RFT 26-083 Interior Renovations & Air Conditioner Upgrades at Frontenac PS

The following, issued by the Halton District School Board (HDSB) June 18, 2026, shall be incorporated in the specifications and shall form part of the proposal document for the above.

TENDER ADDENDUM NO. 1
2026.06.17

Interior Renovations and Air Conditioner Upgrades at Frontenac Public School
Halton District School Board RFT 26-083
5140 Pinedale Avenue, Burlington, Ontario

Drawing No.: **A1.2**

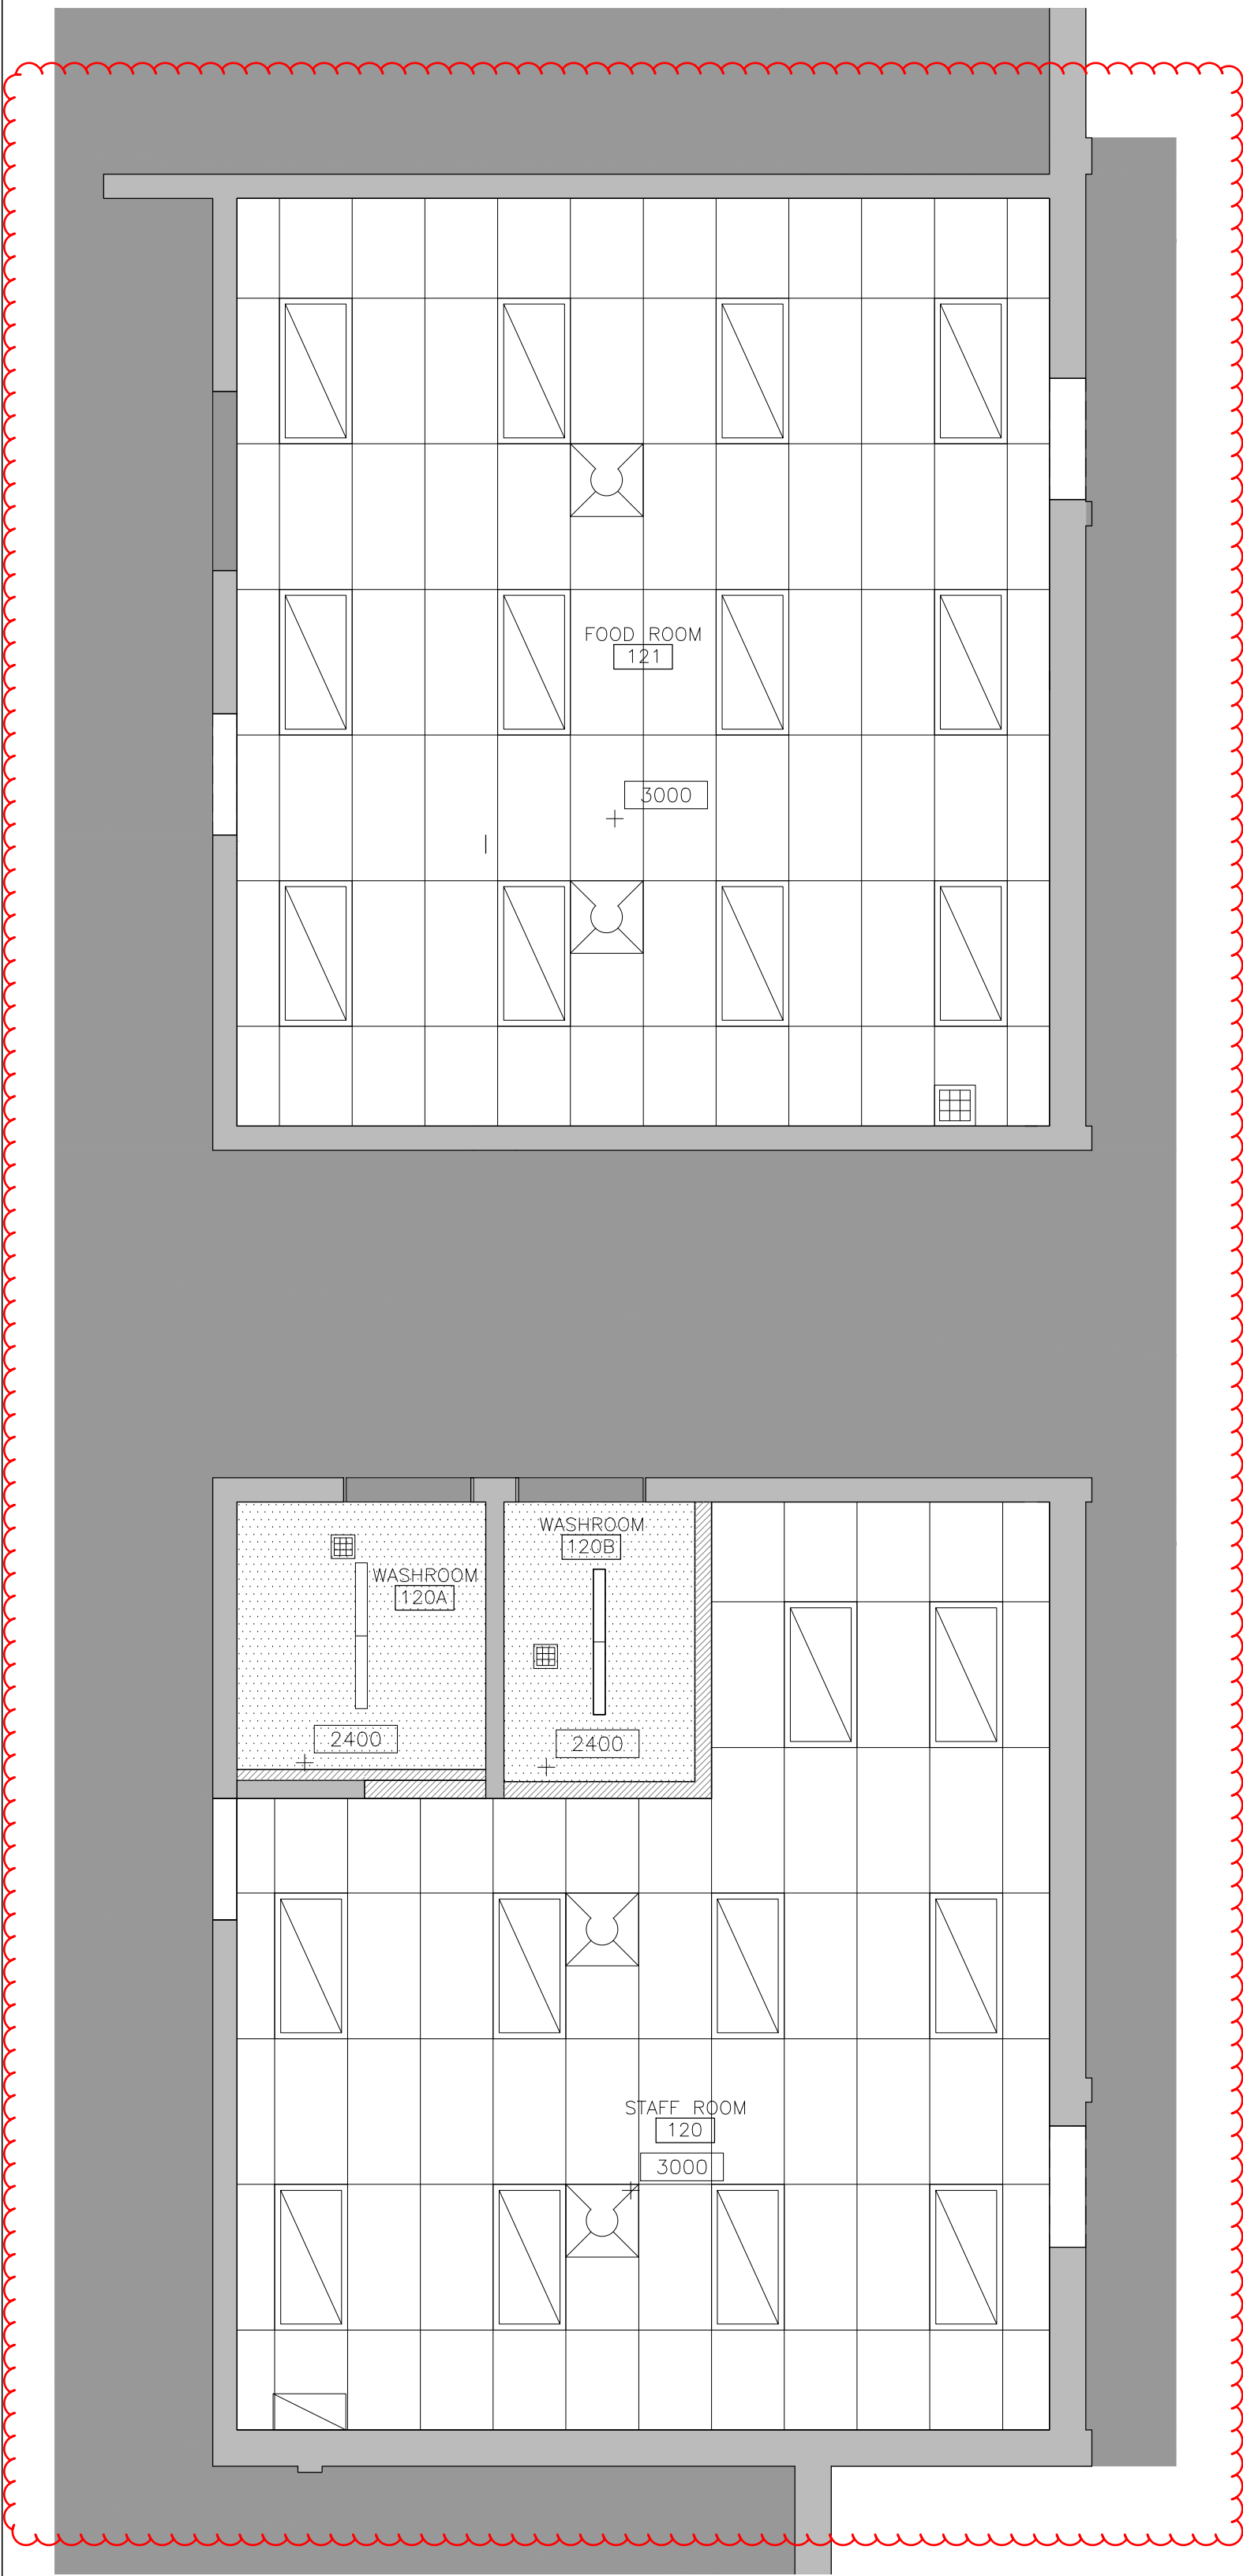
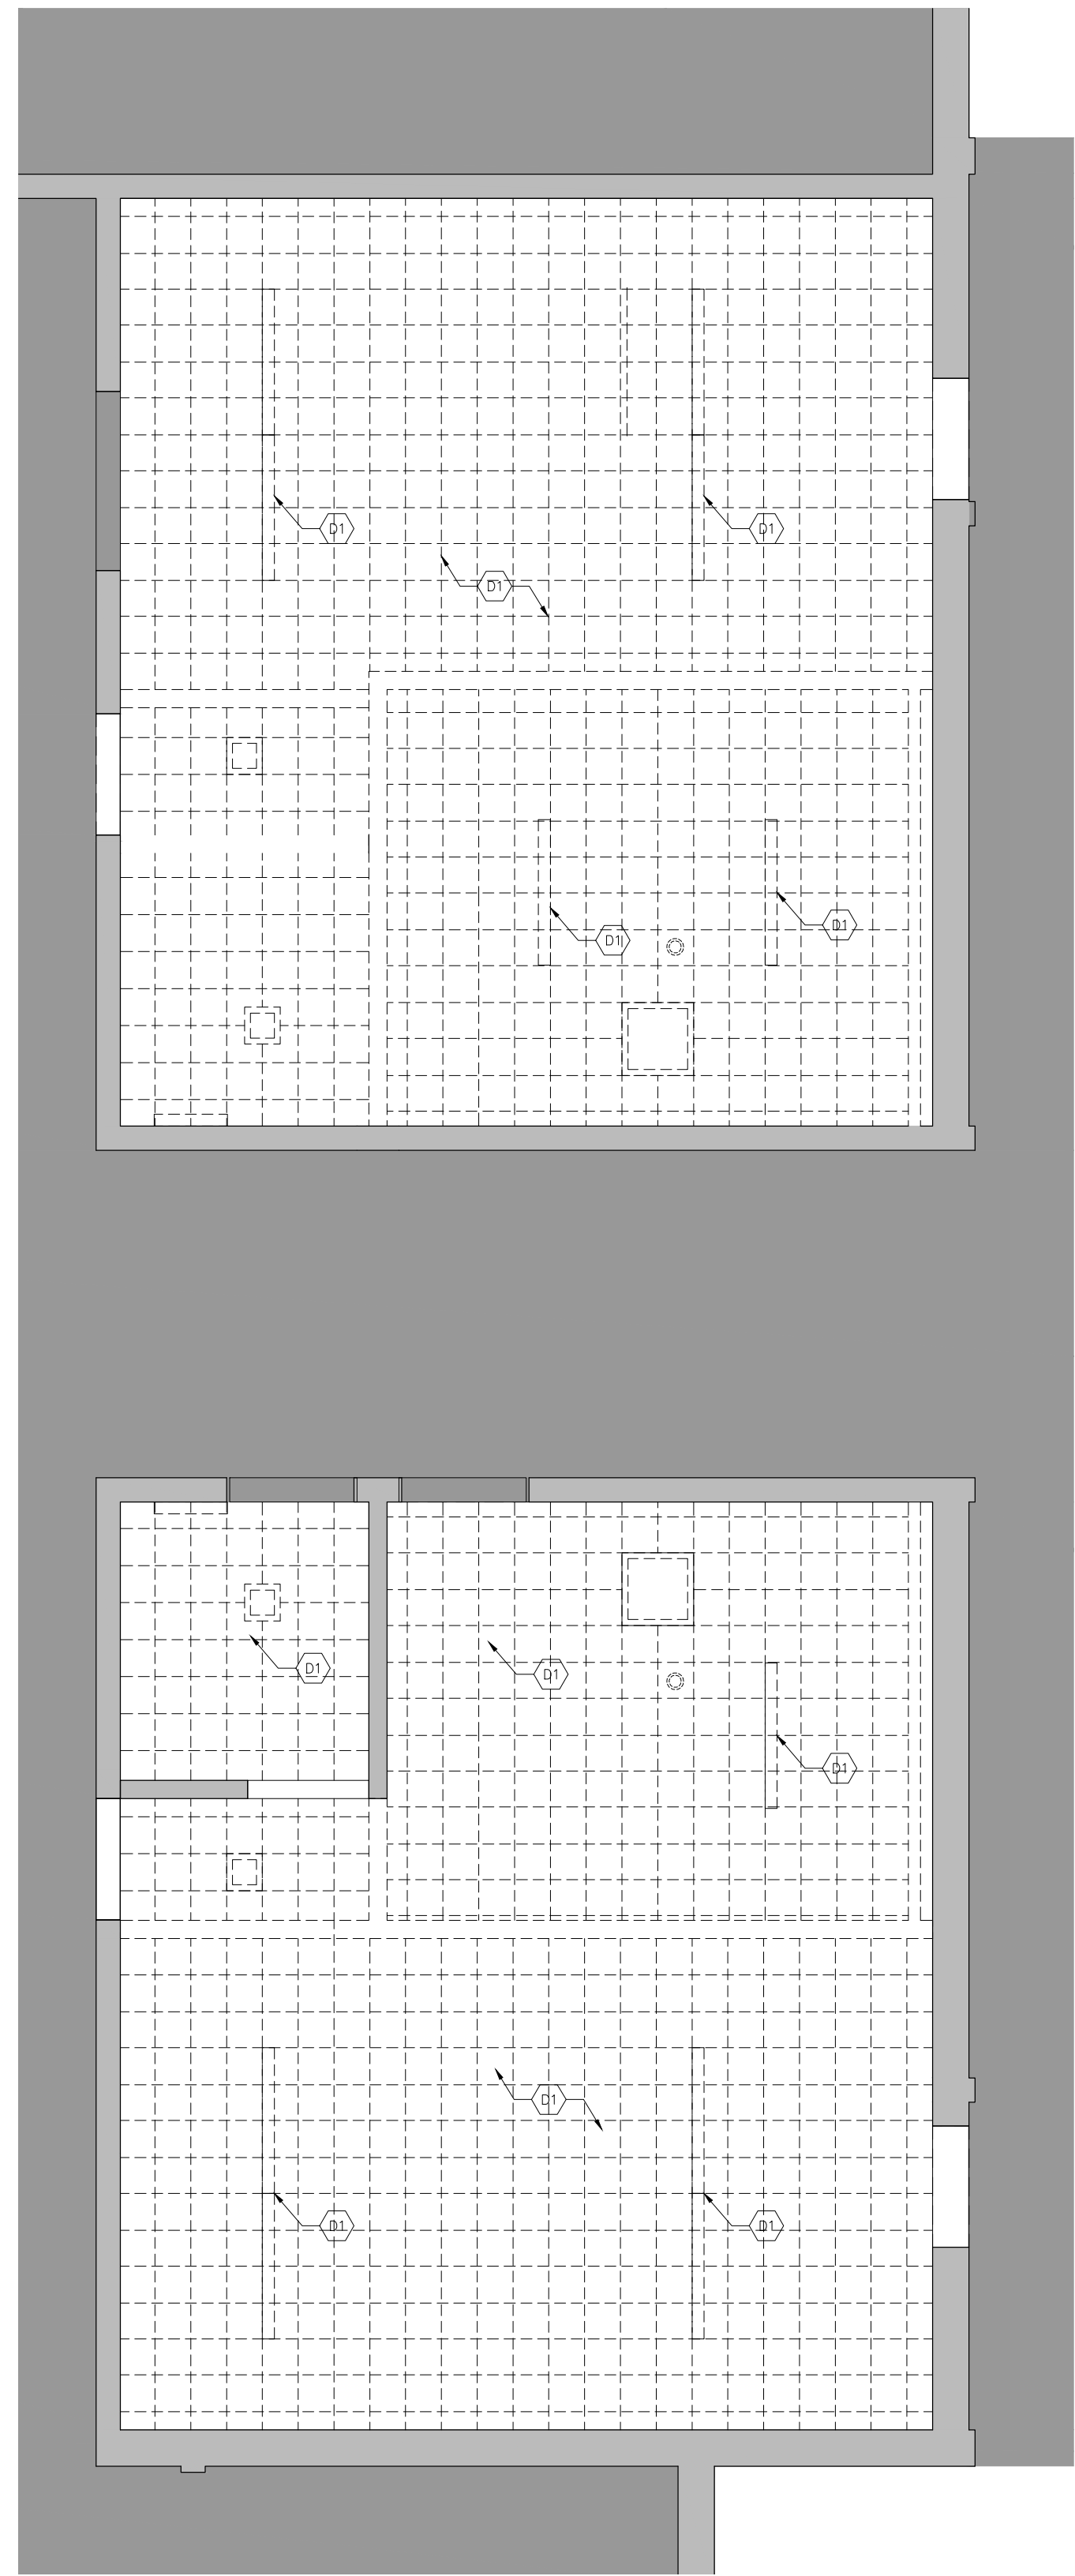
1.4: Drawing A1.2 Demolition & Proposed Second Floor Plans:

1. ADD to Interior Elevation 3/A1.2 reference bubbles to detail millwork sections. See attached revised drawing A1.2 with bubbled revisions.
2. ADD Millwork Elevation Detail 5/A1.2 and Millwork Section Details 6/A1.2, 9/A1.2 and 11/A1.2. See attached revised drawing A1.2 with bubbled revisions.
3. 10/A1.2 Section – Serving Hatch relocated from drawing A1.1. See attached revised drawing A1.2 with bubbled revisions.
